Our Ref: PL17/0002 and ECM common number  
Contact: Gavin Cherry  
Telephone: (02) 4732 8125

**Pre-lodgement Advice  
Proposed Development Lot Consolidation & Expansion of Existing  
Industrial Facility  
Lot 12 DP 1087962 , Address 24-27 Lambridge Place PENRITH NSW 2750**

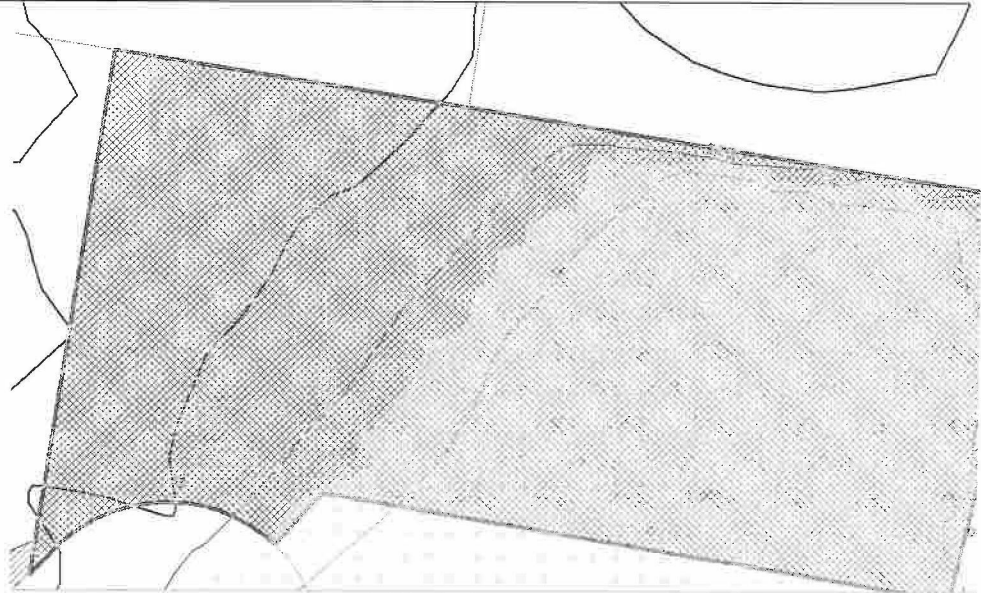
- The site is affected by mainstream and local flooding
- Natural ground levels on Lot 11 of DP 1087962 have been altered within the 1 in 100 year overland flow path

- All plans for the site shall have levels and details to AHD.
- The proposed new building to be located on the existing lot 11 will conflict with the local overland flows that traverse the site. An assessment by a suitably qualified engineer must be provided to demonstrate that the development will not impact the existing 1 in 100 year overland flow path. The extent of the 1 in 100 year local flooding can be found on Council's 2006 Flood Study and can be accessed on our website. It appears that filling has occurred on eastern portion of the site which should generally require to remain at existing ground levels (as noted by Council's system), any alteration to the ground levels will require the preparation of an overland flow report.
